CHANCE
MANUFACTURING CO., INC.

Service Information

Ride: YO YO

Subject: GUSSET PLATE ADDITION

King Pin Section of Trailer

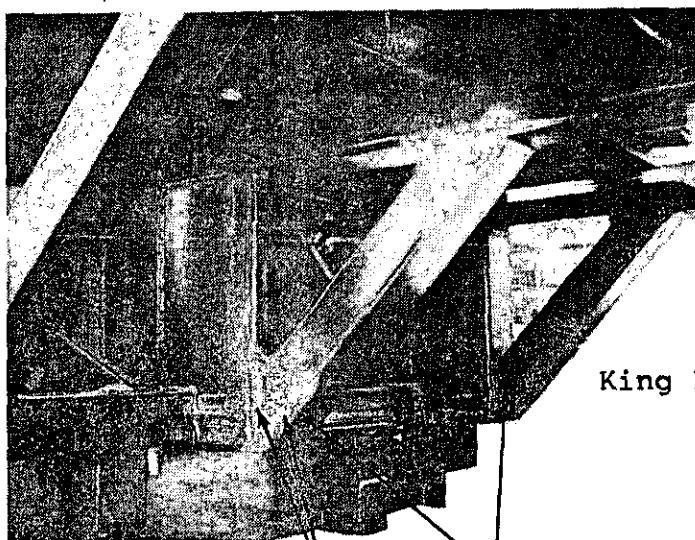
Because of a combination of factors, among them rough road conditions, one area of the YO YO trailer is receiving a higher degree of stress than was expected. This has resulted in the partial failure of the weld joints.

As soon as we receive the enclosed card from you, we will ship eight gusset plates which should be added to the trailer as shown.

It is important that these gusset plates be added even though your trailer presently shows no signs of fatiguing.

3/8 inch Fillet Weld-two sides-
E70XX Rod

Weld gusset plates on both
side of tube
